Response to Submissions

State Significant Development Application SSD_8832

St Francis Catholic College K-12 and Learning Centre

Submitted to the NSW Department of Planning and Environment
On Behalf of The Catholic Education Office

Figure 2: Extract from Tree Management Plan (TMP01 B) – Source: Naturally Trees

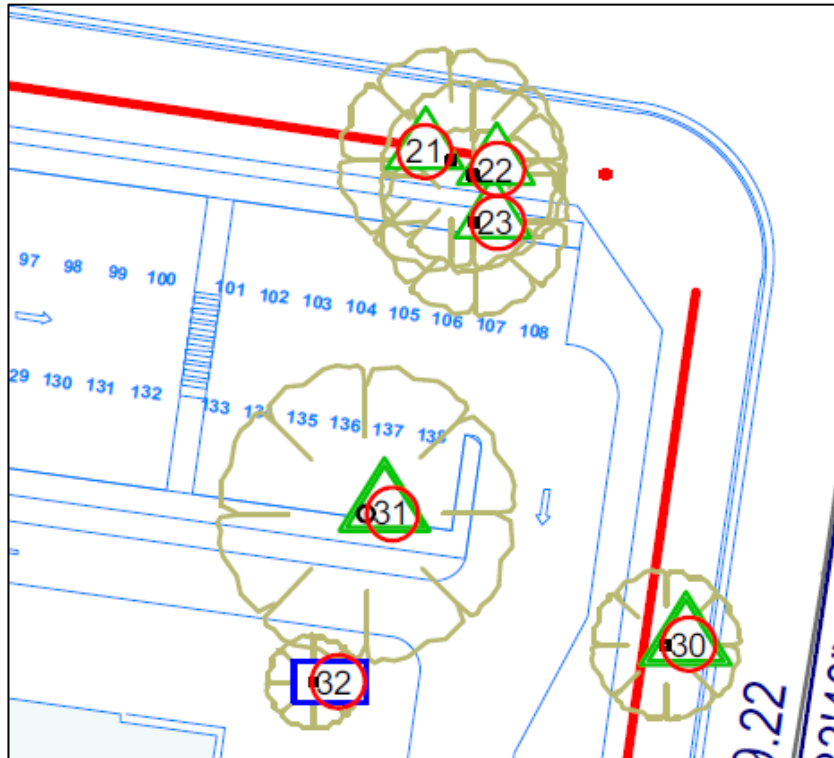
It is acknowledged that several existing trees at the site, particularly trees 21, 22, 23, 30 and 31 towards the north eastern corner of the site, were identified as having high to very high significance.

Investigations to retain such trees were undertaken by the arborist. The investigations reveal that such trees are not likely to survive the current level of development taking place at the site according to existing Development Consents pertaining to the site. As can be seen in the image below, trees 21, 22, 23 and 30 are in very close proximity to civil works associated with the Edmondson Park structure plan, namely the construction of Poziers Road and Vinny Road. The trees in question are not likely to survive such works. Trees 31 and 32 would subsequently be isolated. Given they would be isolated, and the importance of the proposed internal road, their removal is considered warranted.

Given the extent of development proposed as part of the application, and the area of the subject site, the retention of five (5) trees is not considered warranted. An entirely new and integrated landscape response will deliver a better streetscape presentation, as opposed to a new landscape response which retains some existing trees.
